Mobile Devices Ingénierie

Product Equality Declaration

We, Mobile Devices Ingénierie, declare on our sole responsibility for that the model C4MAX is exactly the same as the original certified product with FCC ID A6GC4MAX-3GNA, except for the difference specified below:

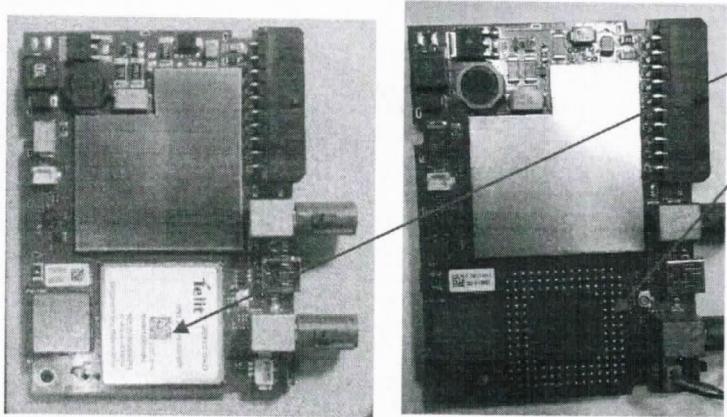
The only difference is there's no module on new product that we are going to sell

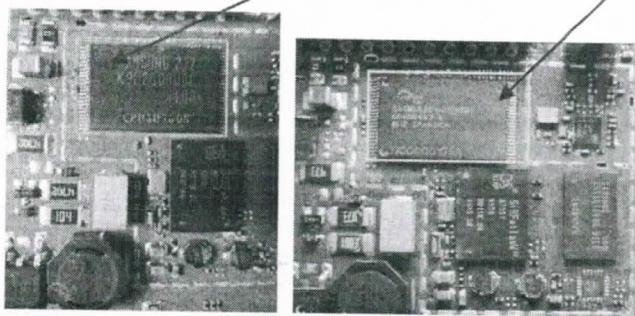
- We remove module, so there's no WCDMA, no GSM function

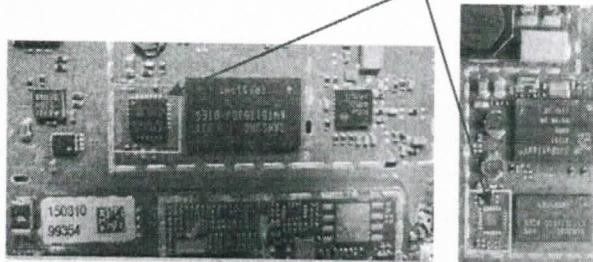
- We changed flash from Samsung brand name to Spansion, because the old flash is end of life
